Reviewer Response:

This review is for egusphere-2025-5261, titled, Evaluation of Pandora HCHO and NO₂ with Airborne In Situ Observations. In this analysis, the authors evaluate Pandora HCHO and NO₂ columns using in situ data from the NASA DC-8 during the AEROMMA period and also compare to TEMPO data. This evaluation is more a case study analysis rather than a statistical evaluation of the Pandora retrievals. Overall, the authors have done a dense analysis during these cases but is recommended for publication after a number of minor revisions are addressed as discussed below.

Review of “Evaluation of Pandora HCHO and NO₂ with Airborne In Situ Observations”

TEMPO column HCHO in NYC at 8 am EDT (top) and 11 am EDT (bottom) on August 8th, 2023.

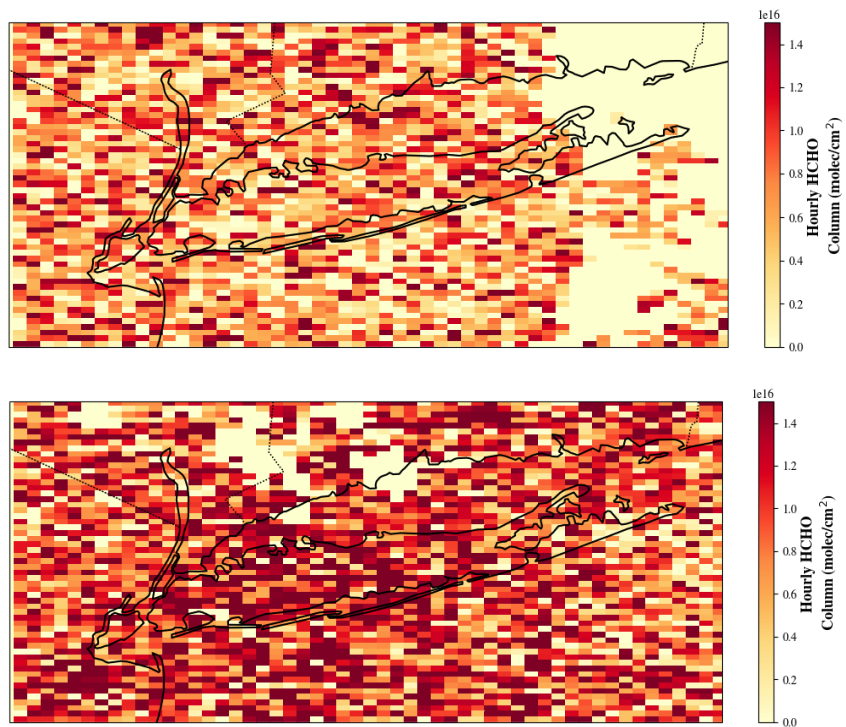
Figure 5 and Line 427: Are these TEMPO data that are collocated over the Pandora sites or are they over the whole domain shown in Figure 7? If the latter, this is not a valid comparison as the majority is over water where on NYC4 you show that all the high levels are over land. This is skewing the analysis. They should not be quantitatively compared in this way.

Figure 8: Please clarify in the discussion that each point represents a TEMPO scan time (if this is the case). However, it implies that TEMPO is averaged over the whole domain rather than at the Pandora sites. As stated above, this is not a valid method for quantitative comparisons. Data should only be considered over the Pandora sites and a spatial matching criteria should be stated.

3. Figure 8:

Please describe the spatial domain and collocation criteria used. Also discuss how the choice of domain may influence the observed biases.

The TEMPO columns in this analysis are averaged over the entire NYC domain in Fig. 2, rather than collocated directly with individual Pandora locations. We acknowledge that portions of this domain extend over the ocean, which may introduce a low bias in TEMPO HCHO columns due to generally lower marine values. These comparisons are therefore intended to provide qualitative context rather than strict quantitative validation, given the spatial mismatch between satellite pixels, Pandora observations, and aircraft sampling.

Due to the noise and uncertainty in TEMPO HCHO retrievals, a relatively large spatial domain is required for averaging; however, this choice introduces representativeness limitations that must be considered when interpreting differences. Two hourly HCHO retrievals from TEMPO are included at the bottom of this document to demonstrate the noise in HCHO columns.

Fig. 8 figure caption has been updated. The following lines have been added (lines 506-510) “There is also potential bias associated with the choice of domain used for the TEMPO averaging. Due to the uncertainty and noise in TEMPO HCHO retrievals, a relatively large area is required for spatial averaging. However, portions of this domain extend over the ocean where HCHO columns may be lower than what is observed by the Pandoras. This may cause a low bias in the TEMPO HCHO.”

Fig. 8 figure caption has been updated. The following lines have been added (lines 506-510) “There is also potential bias associated with the choice of domain used for the TEMPO averaging. Due to the uncertainty and noise in TEMPO HCHO retrievals, a relatively large area is required for spatial averaging. However, portions of this domain extend over the ocean where HCHO columns may be lower than what is observed by the Pandoras. This may cause a low bias in the TEMPO HCHO.”
